September 27, 2013

Re: EPA Approval of *Travis Air Force Base Final Third Five-Year Review Report for NEWIOU and WABOU Groundwater Interim Remedial actions, NEWIOU Soil and Sediment Remedial Actions, WABOU Soil Remedial Actions*

4. TITLE AND SUBTITLE Final Third Five-Year Review Report; NEWIOU and WABOU Groundwater Interim Remedial Actions, NEWIOU Soil and Sediment Remedial Actions, WABOU Soil Remedial Actions; Travis Air Force Base, California CDRL A001b; Paragraph No. 9.7.7			5. FUNDING NUMBERS W9128F-11-D-0014 XDAT 20127030

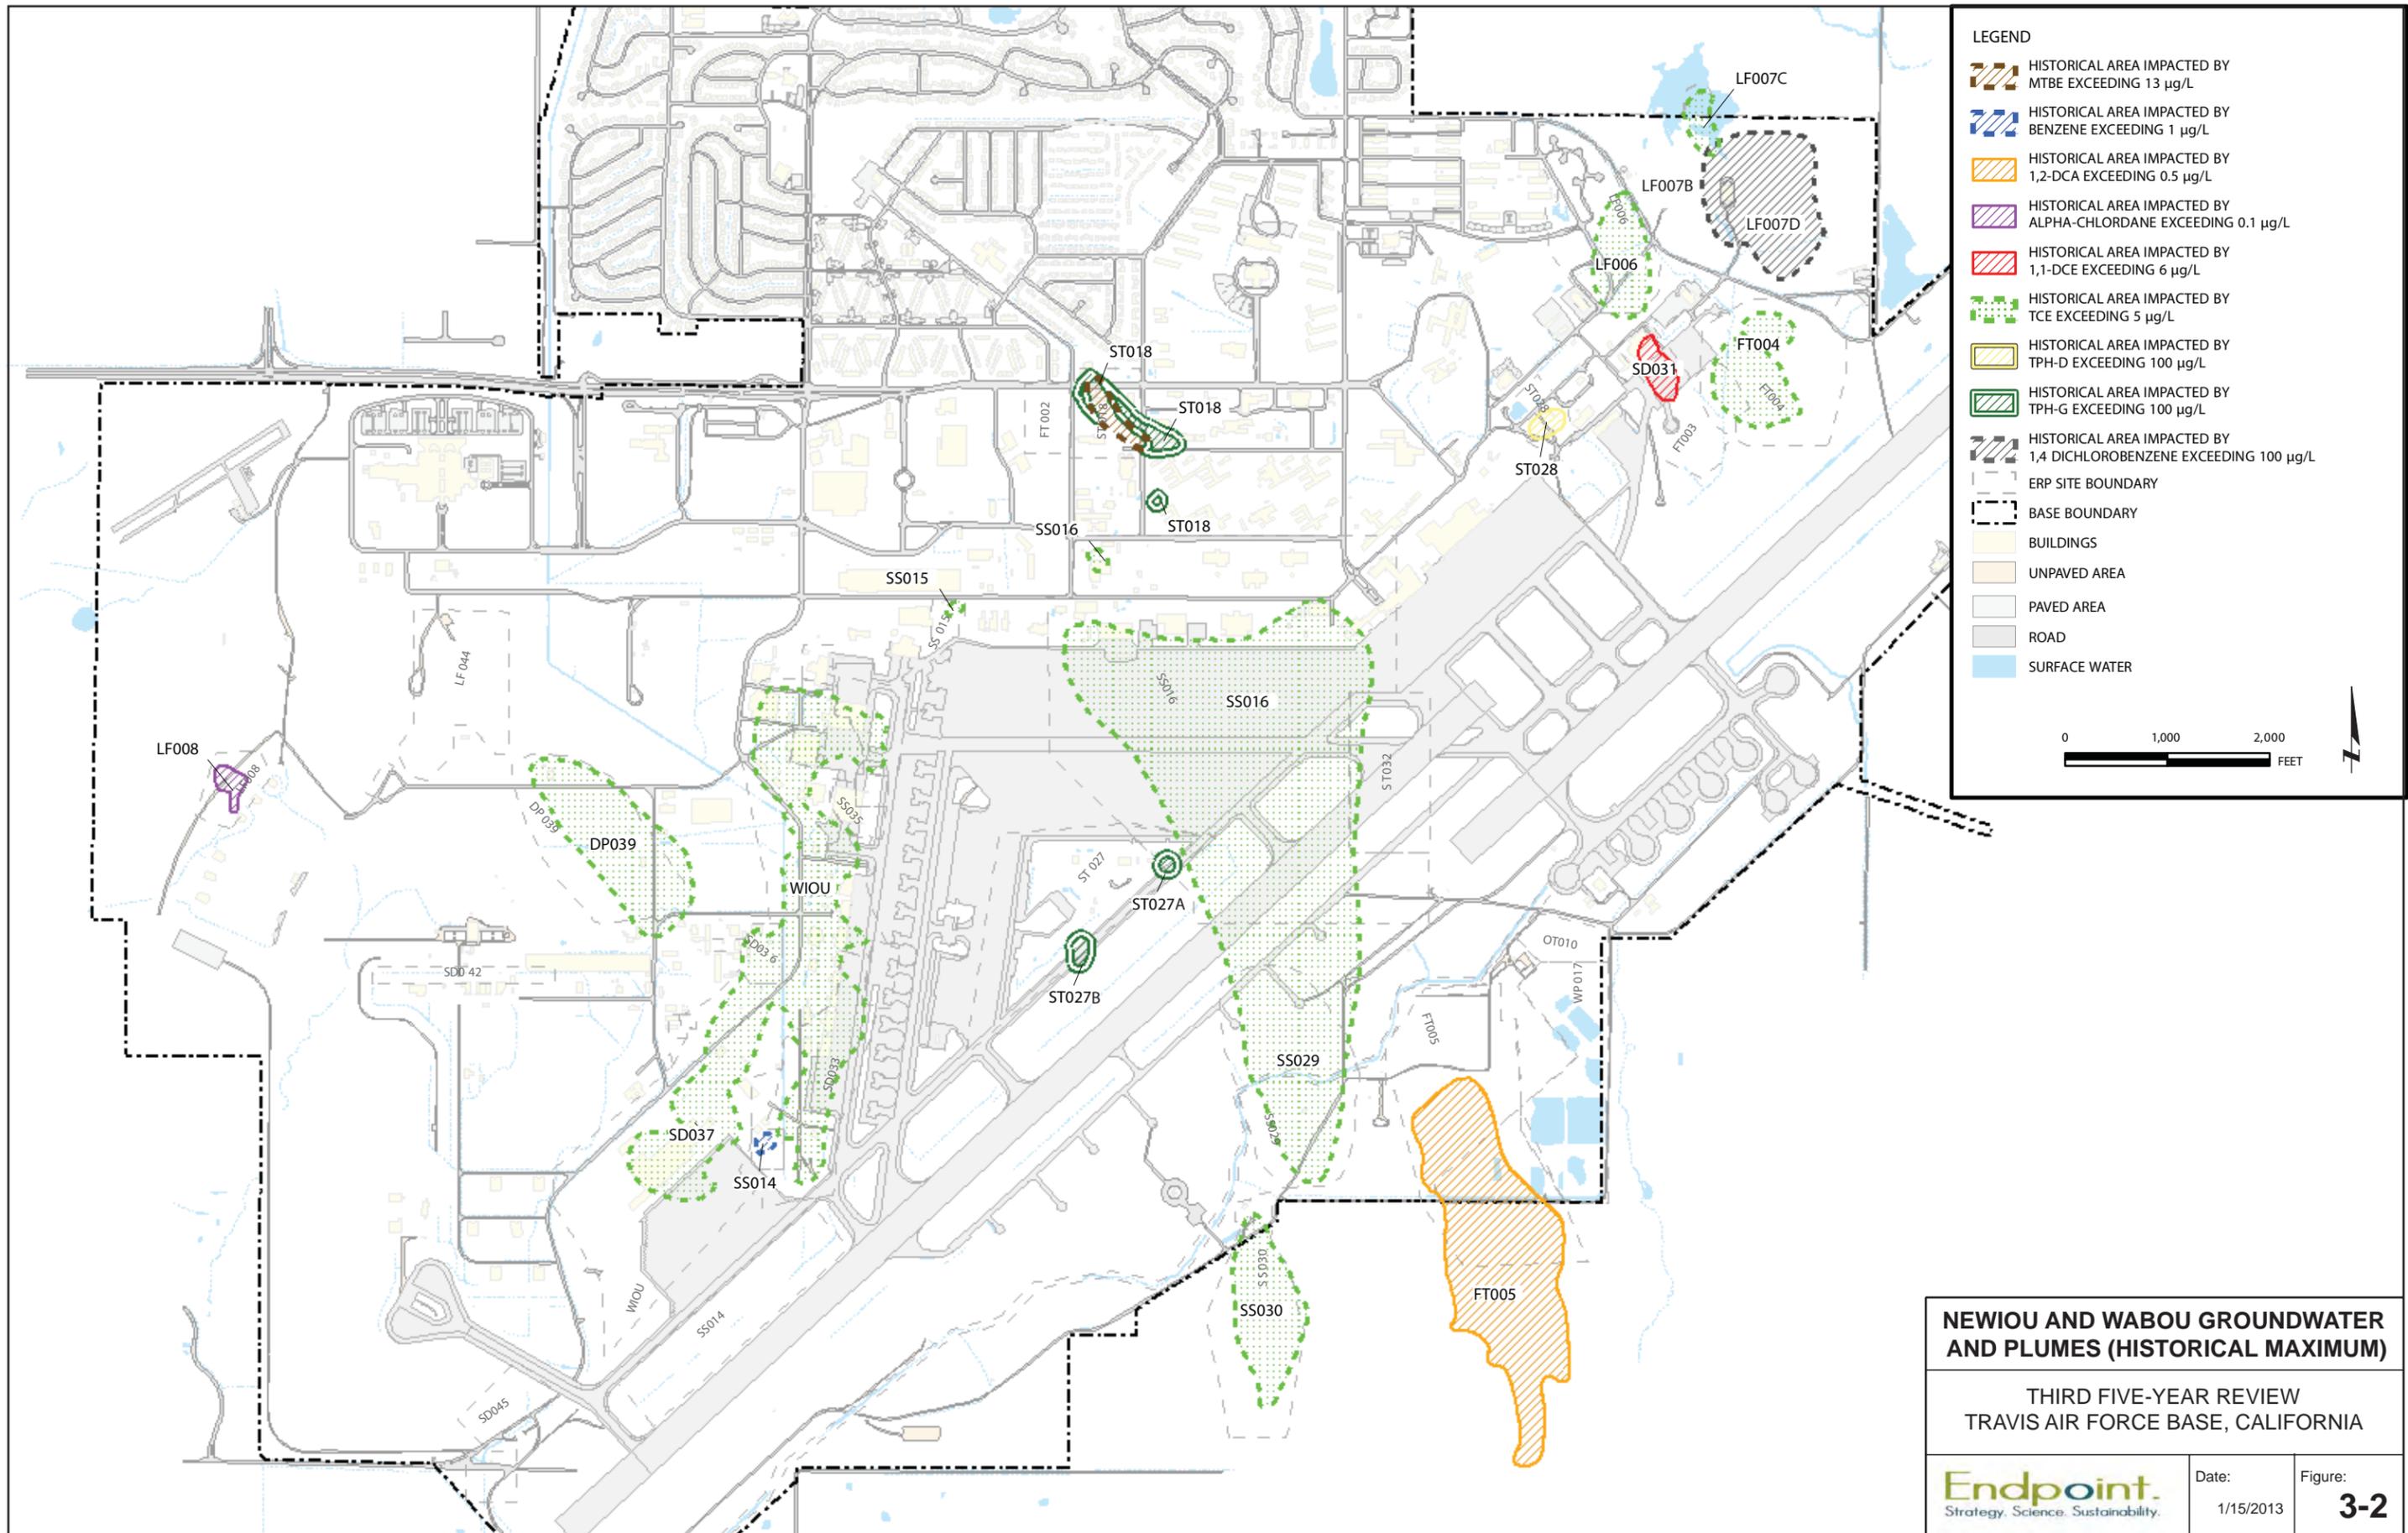
7.	<p>Figure 3-3, NEWIOU and WABOU Soil, Sediment, and Surface Water Sites: Figure 3-3 does not identify the locations of all NEWIOU and WABOU Soil, Sediment and Surface Water Sites addressed in this Five-Year Review and described in Section 3.3.2, Environmental Restoration Program Soil and Sediment Sites. The locations of FT003 (FTA-2), FT004 (FTA-3), FT005 (FTA-4), LF008 (Landfill 3), and SD045 (Former Small Arms Range) are not identified on Figure 3-3. Please revise Figure 3-3 to identify the locations of all NEWIOU and WABOU Soil, Sediment, and Surface Water Sites addressed in this Five-Year Review.</p>	<p>We added all ERP soil and sediment sites to Figure 3-3.</p>

WEST IRA - SITE DP039 TCE DISTRIBUTION 2008 TO 2011		
THIRD FIVE-YEAR REVIEW TRAVIS AIR FORCE BASE, CALIFORNIA		
Date: 2/15/2013	Figure: 7-6

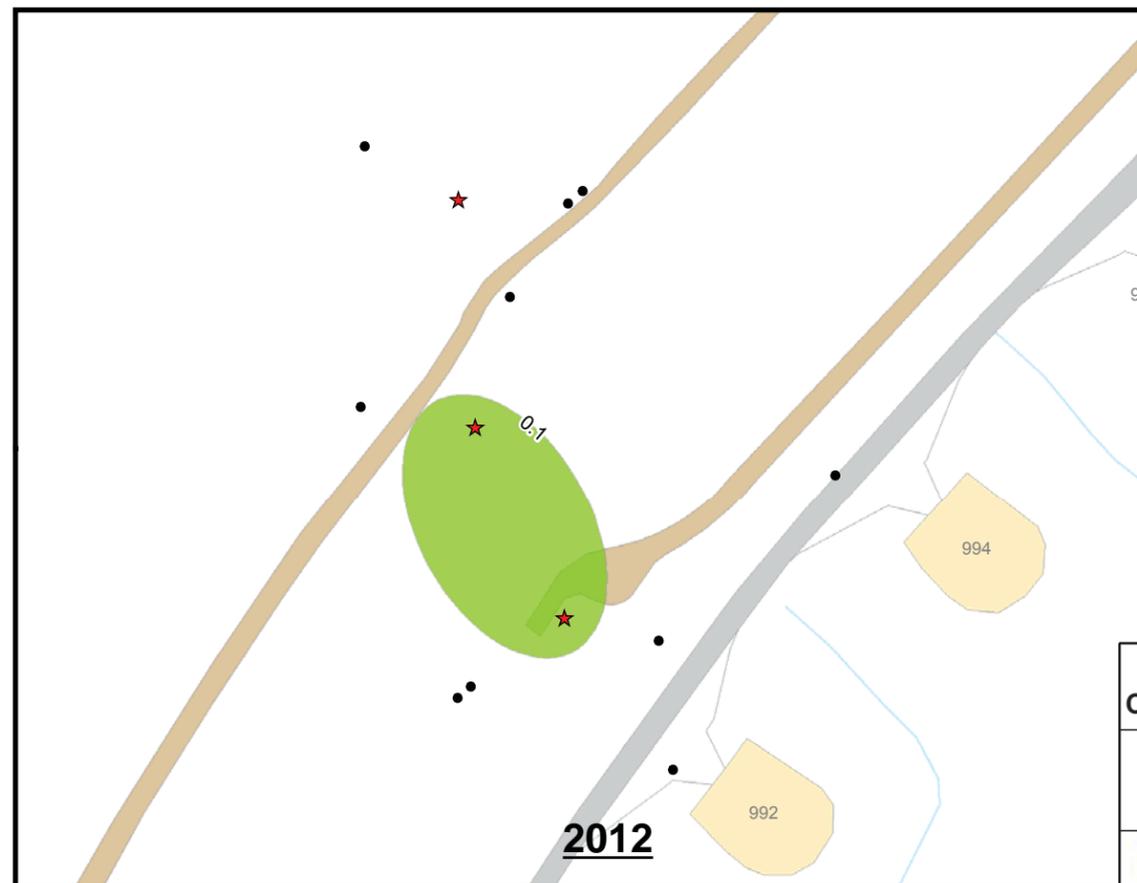
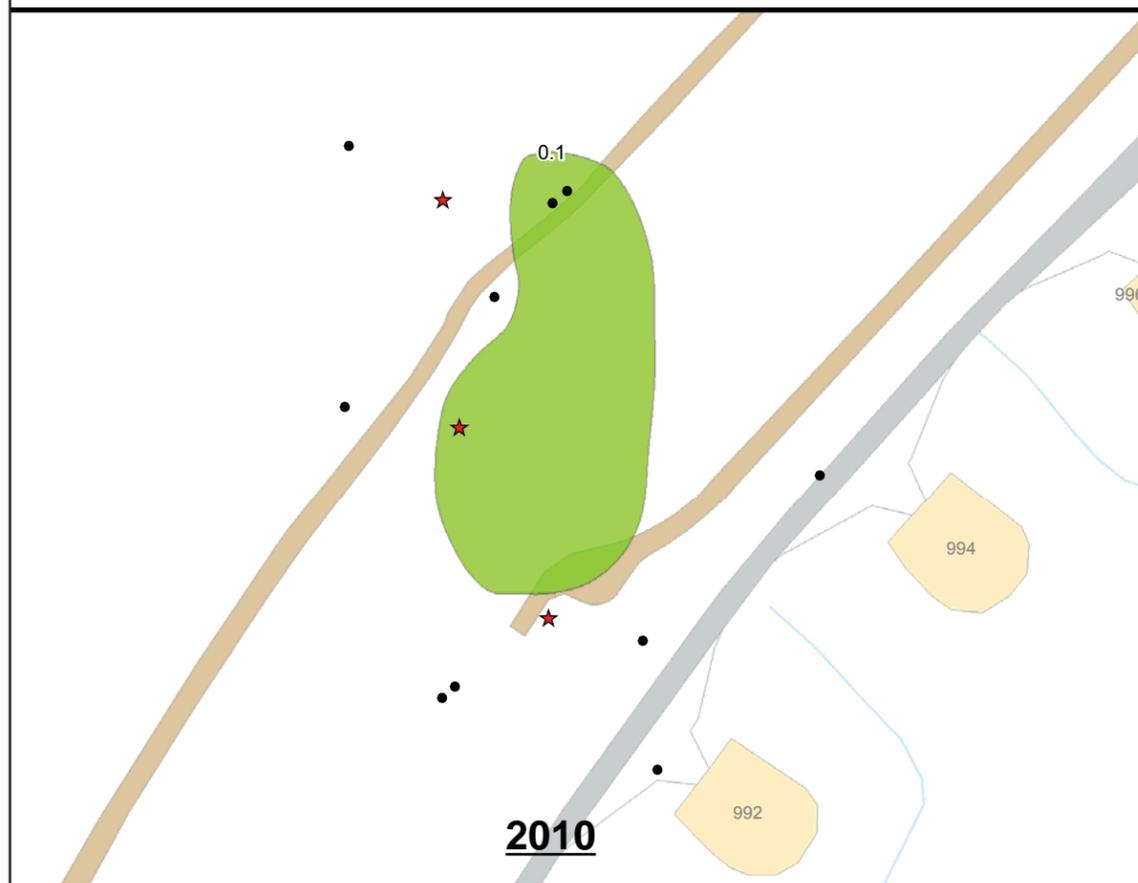
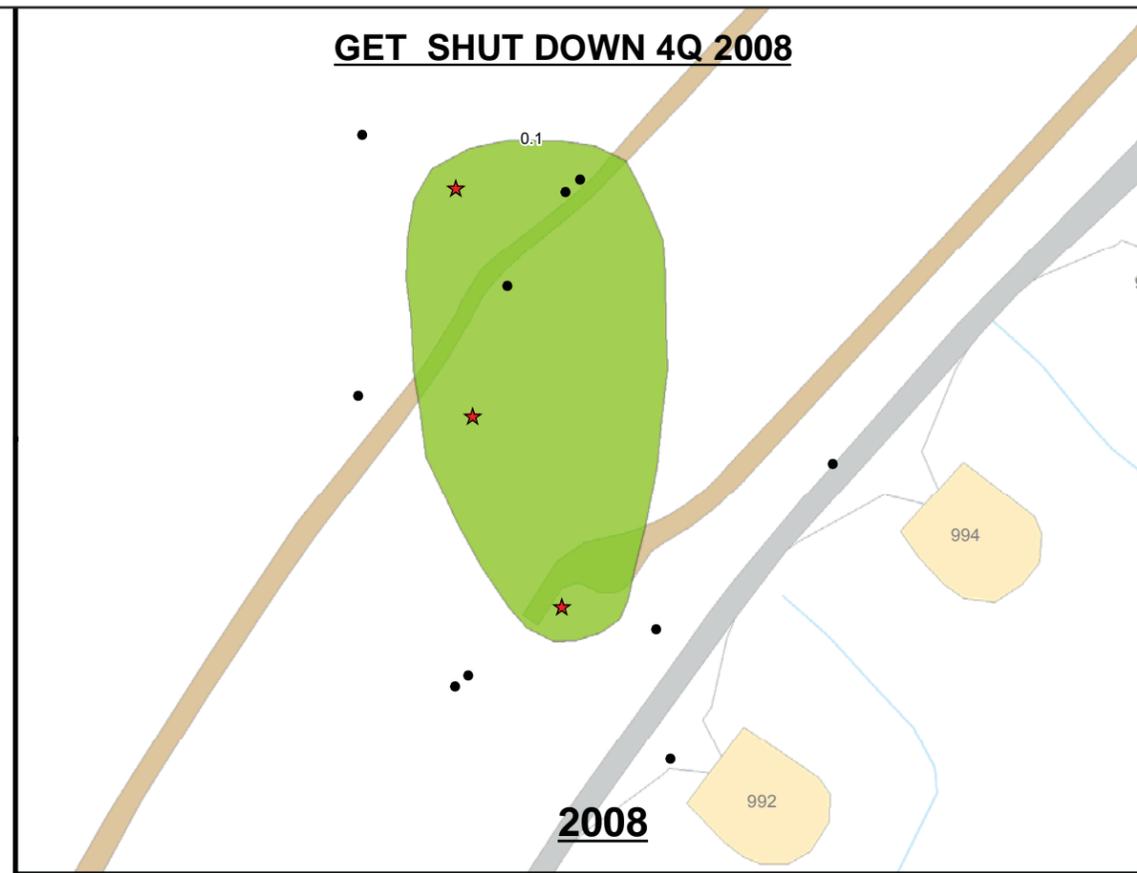
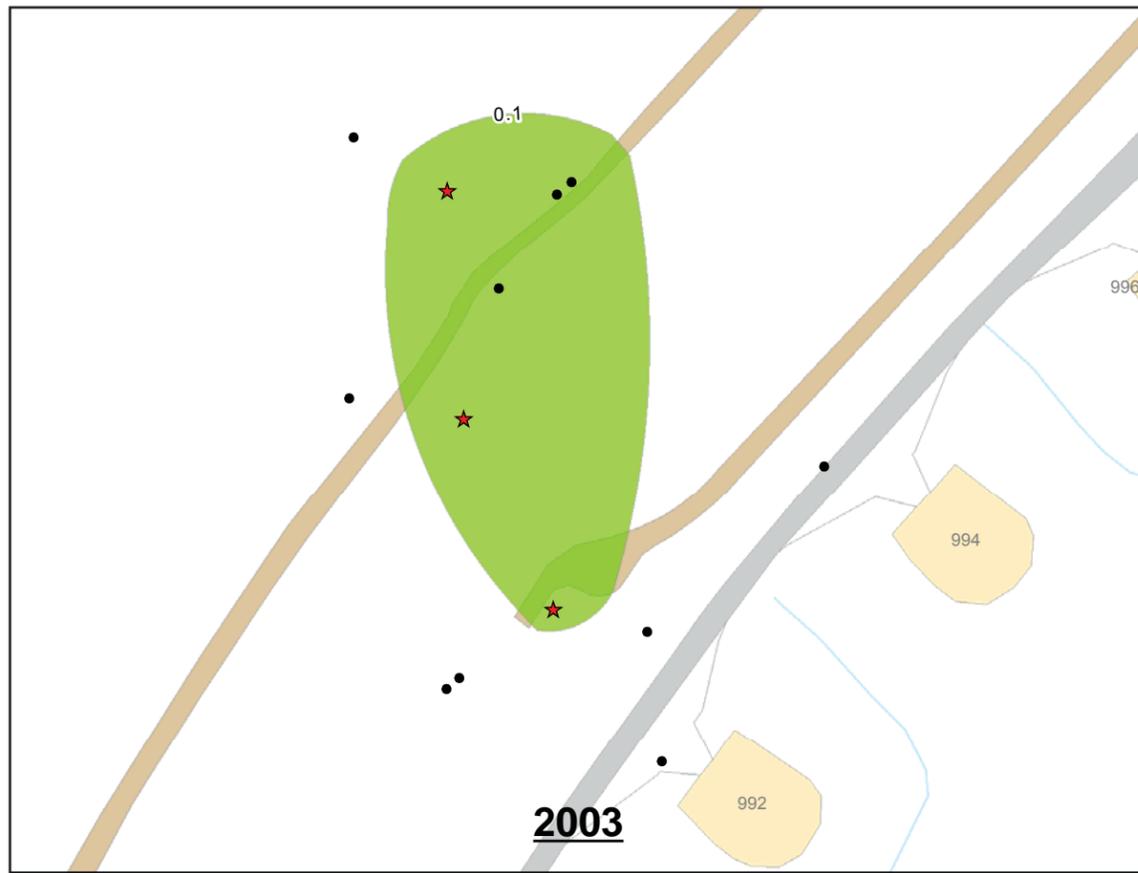
26.	<p>Figure 7-6, West IRA Site DP039 TCE distribution 2008-2011: The plume configurations depicted for 2008 and 2011 are quite different. It is not clear if this is due to the installation of</p>	<p>Comparison of the two plume configurations shown on Figure 7-6 (for 2008 and 2011) reveal changes in both magnitude and extent in the TCE plume over this time period. As discussed extensively in</p>
